ITB06-015

VOLUNTARY RECALL CAMPAIGN 2005 FX; CHILD SEAT ANCHOR BRACKETS

CAMPAIGN I.D. # / NHTSA #: R0604 / 05V-338

APPLIED VEHICLES: 2005 FX (S50)

Repair Overview

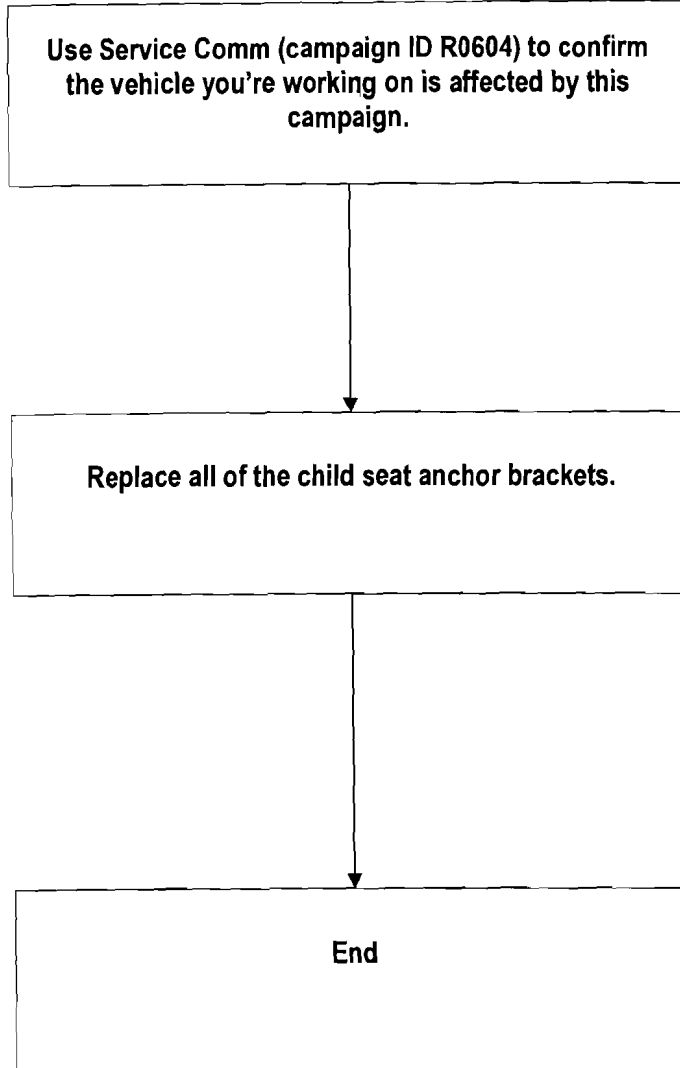
Federal Motor Vehicle Safety Standard (FMVSS 225) specifies certain requirements for child seat anchorage systems in vehicles. Some 2005 model year Infiniti FX35/45 vehicles may have rear child seat safety anchor brackets which do not meet the location requirement in this standard. This may cause difficulty in attaching some child seats to these brackets. If a child seat is not secured, there is an increased risk of injury in a crash. Infiniti is conducting a Voluntary Safety Recall Campaign to install longer rear child seat anchor brackets free of charge.

New Child Seat Anchor Brackets

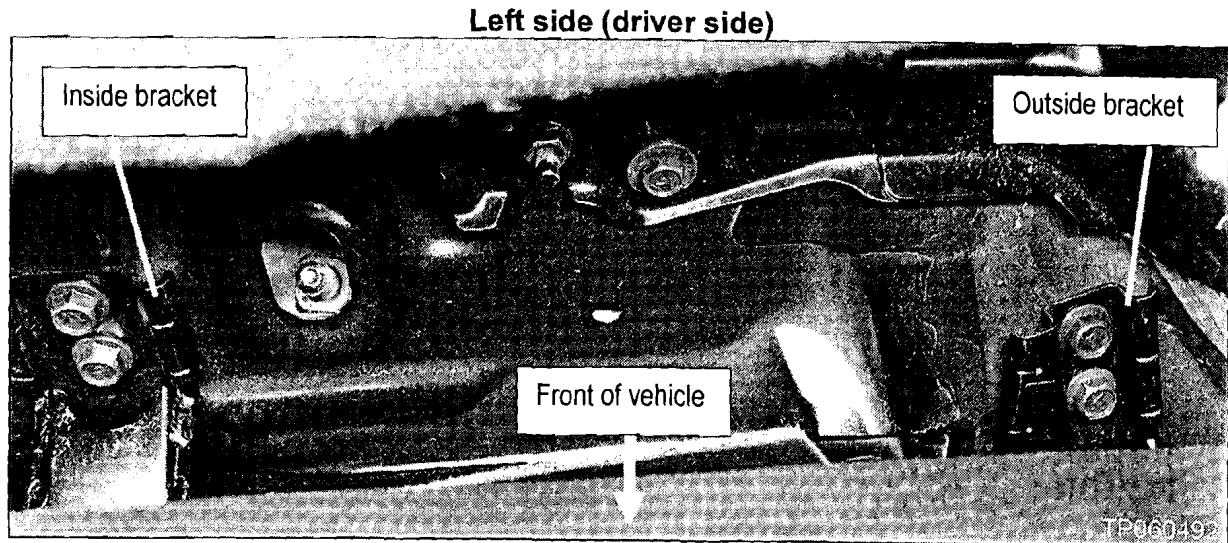
4. Look in the cavity behind the seat and locate the child seat anchor brackets.

5. Replace the brackets with the new ones (both sides; left and right).
 - Make sure to use the correct outside brackets.
The one for the left side (driver side) is marked with an "L"
The one for the right side (passenger side) is marked with an "R"
 - Reuse the original bolts
Torque the bolts to 28.4 N.m (2.9 Kg-m, **21 ft-lb**)
6. Reinstall the sound insulator and fold UP the seatbacks.
